Burlington Design Advisory Board

DESIGN ADVISORY BOARD Tuesday May 25, 2021 3:00 PM REMOTE MEETING

To: Design Advisory Board
From: Ryan Morrison, Associate Planner
Date: May 25, 2021
RE: 21-0910CA; 125 South Cove Road

To: The Design Advisory Board
From: Mary O'Neil, AICP, Principal Planner
RE: ZP 21- 0927CA; 79 Pine Street
Date: May 25, 2021

Garage
Elevation

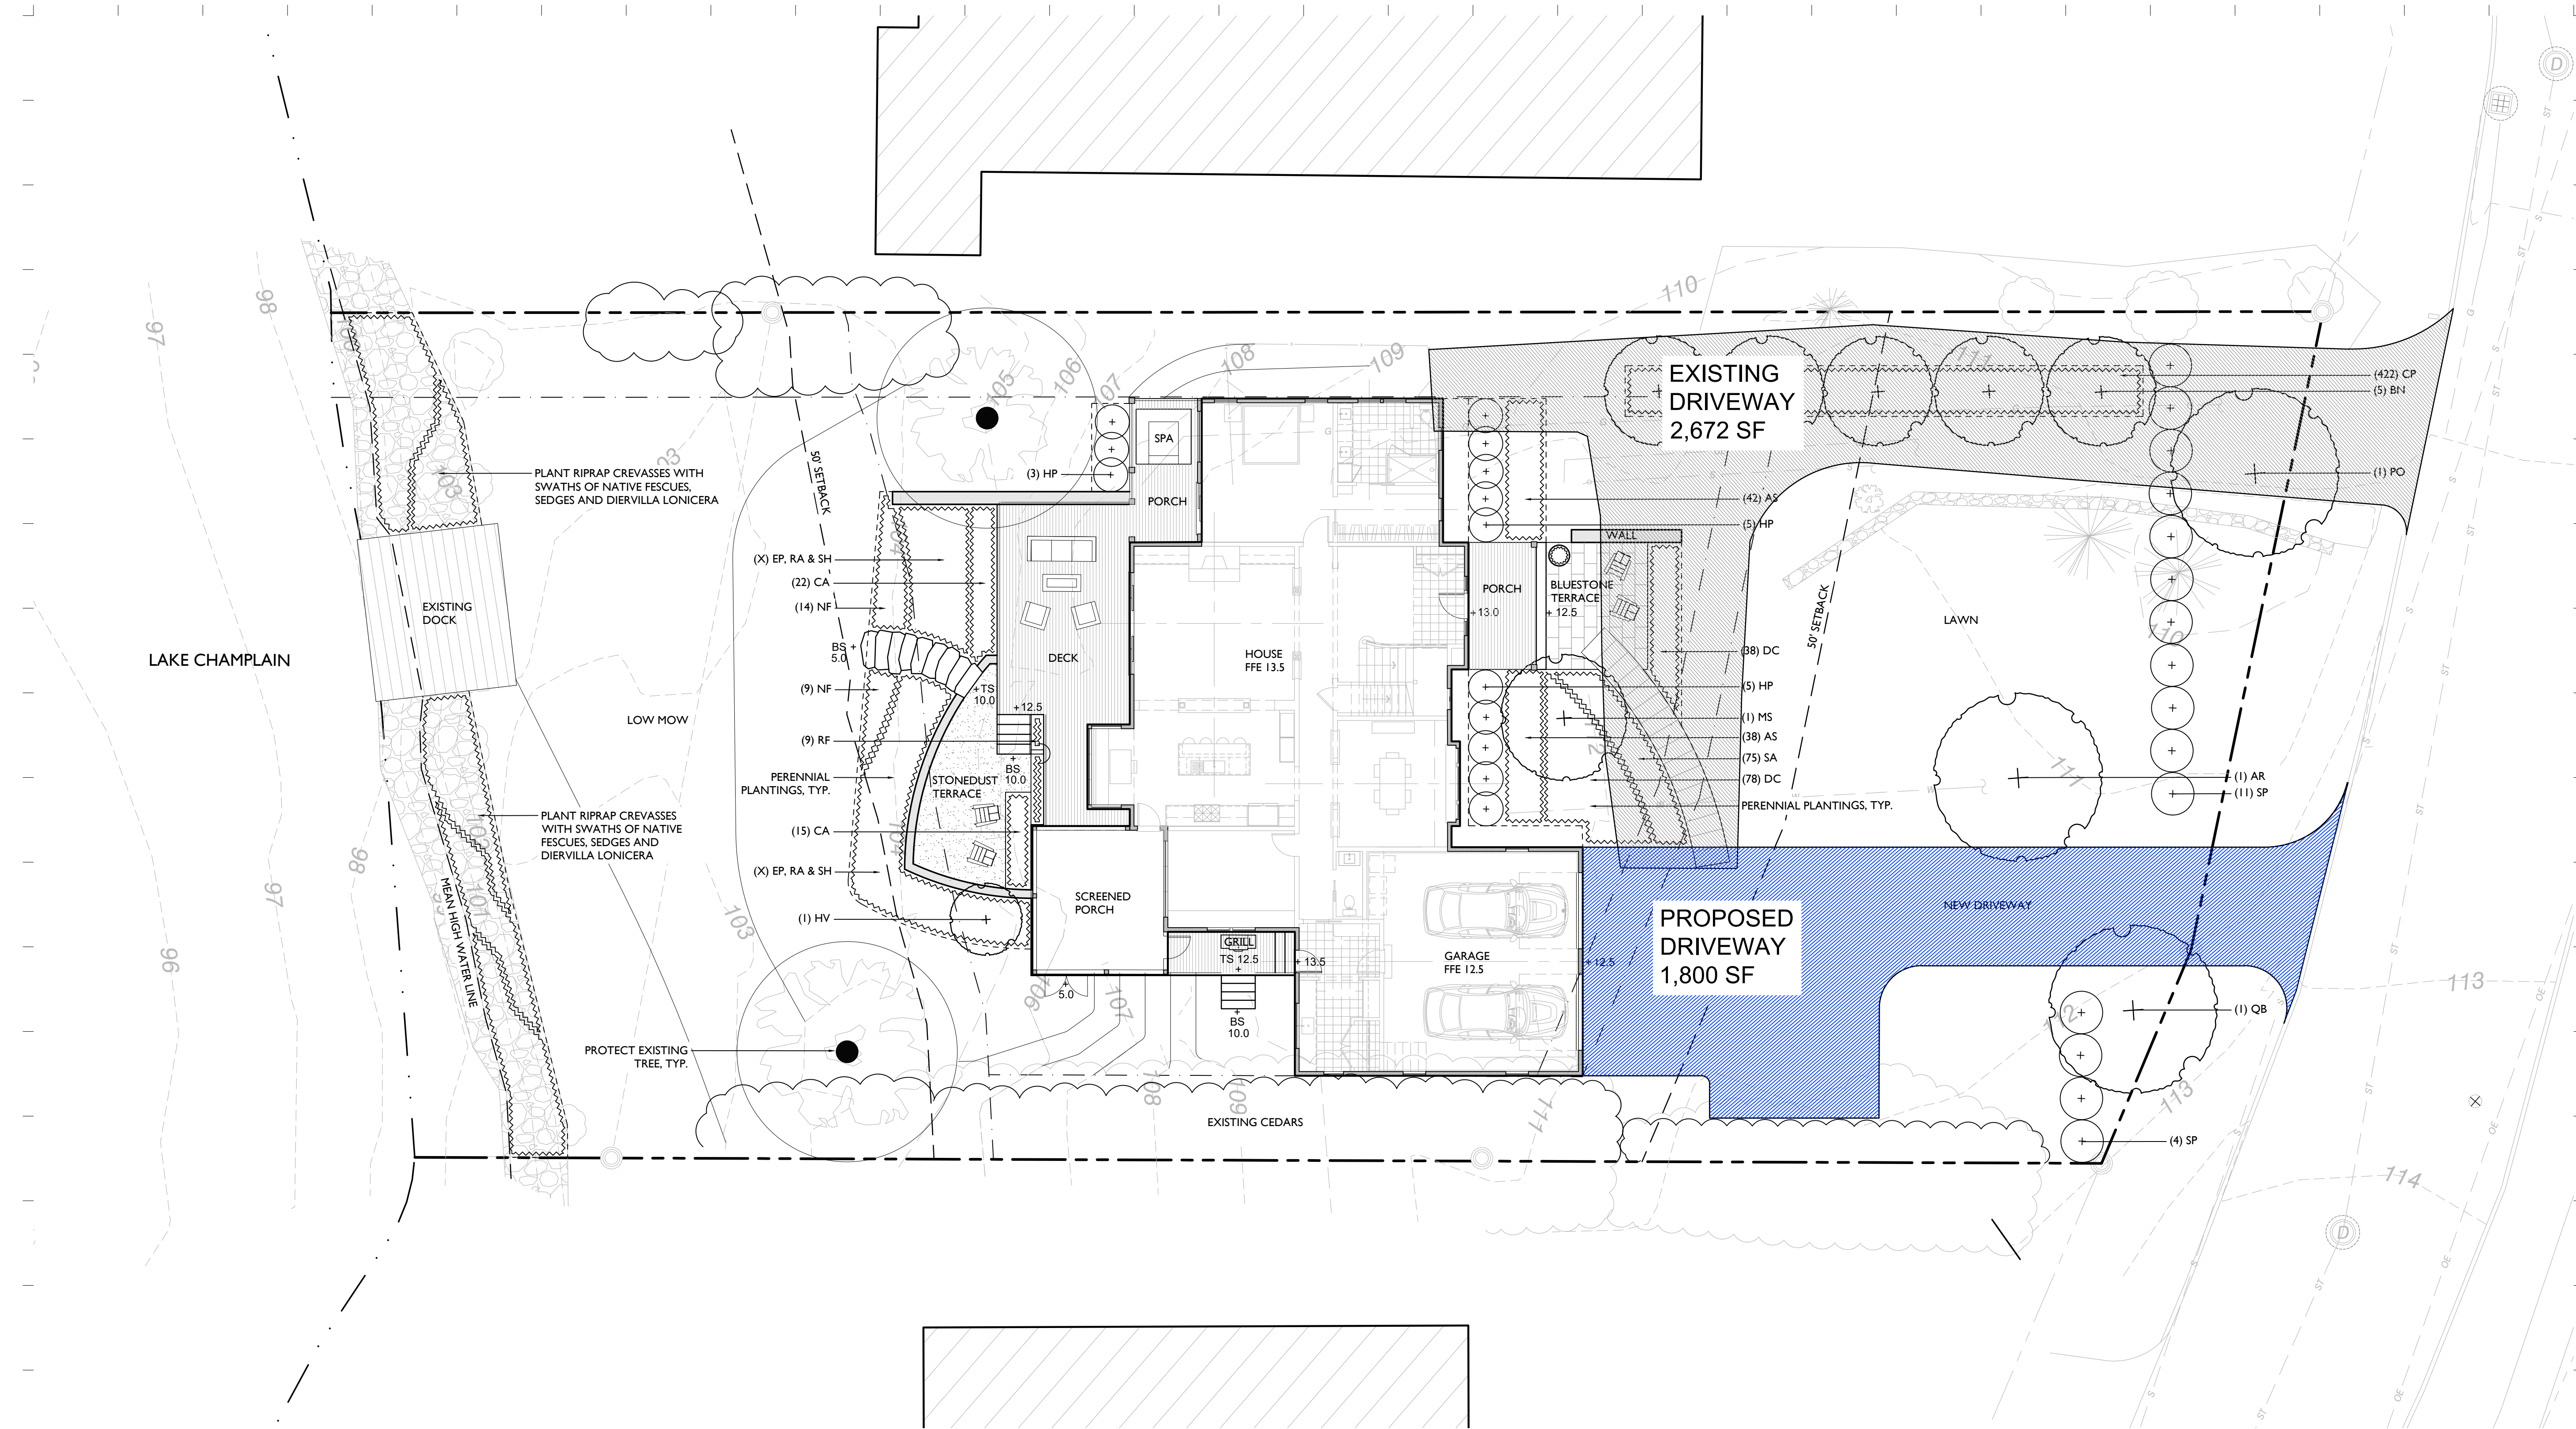
While the attached garage is consistent in character and design with the new home, it is not setback from the longest street facing wall of the home, and it needs to be. While there are examples of garages that are the foremost feature of many nearby homes, this was not a requirement when those homes were constructed. The project must comply with this current requirement, which may result in a significant redesign to the proposal.

- The garage, as proposed, is the foremost feature of the new home, and as a requirement of Sec. 6.2.2 (h) needs to be setback from the longest street-facing wall of the principal structure.
- All portions of the driveway/turnaround area within the front yard setback need to be reduced in width to no more than 18 ft.
- The rear deck and stonedust terrace cannot encroach any closer to the shoreline than existing development.
- Elevation and site plans need to be updated to show all light fixtures, the mailbox, utility meters, and any other mechanical units.
- Is a pedestrian walkway between the home and the street an option.
- Floor plans for all floors need to be submitted.
